# UNITED STATES PATENT AND TRADEMARK OFFICE

APPLICATION NO.	FILING DATE	FIRST NAMED INVENTOR	ATTORNEY DOCKET NO.	CONFIRMATION NO.
10/687,440	10/16/2003	Michael J. O'Brien	86847SHS	8770

**Office Action Summary**

**DETAILED ACTION**

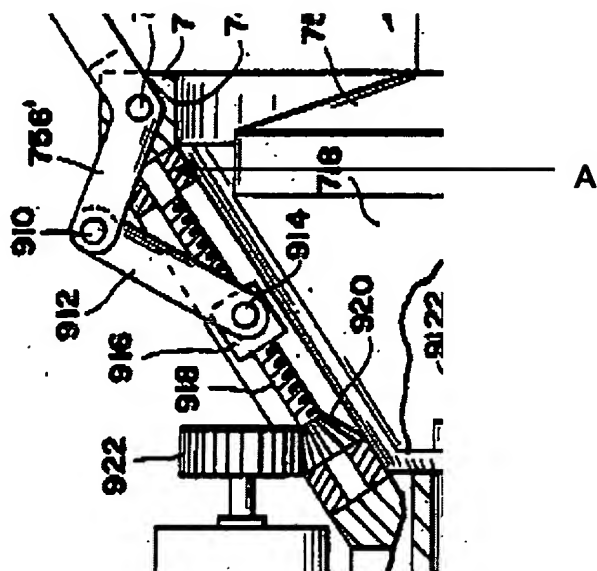
positioning a plurality of clamping pawls **756** over a clamp plate **7550** to fully capture the clamp plate preventing displacement from a latch seat **742**;

making contact with the clamp plate with a follower link **756'** in a manner as to equalize forces on the clamp plate;

applying a force to the clamp plate by effectively grounding the follower link of a four bar mechanism (via coupler link **912**), thereby, forming a simple lever to obtain mechanical advantage at the clamp plate;

providing a clamping force on the clamp plate by deforming a coupler link **912** via a cam **916**; and

locking the precision latch in its final state with action from (abutting abutment member **A**; Figure 9 reprinted below with annotations) a fixed displacement portion (end face of cam **916**) of the cam (Figures 7-9).
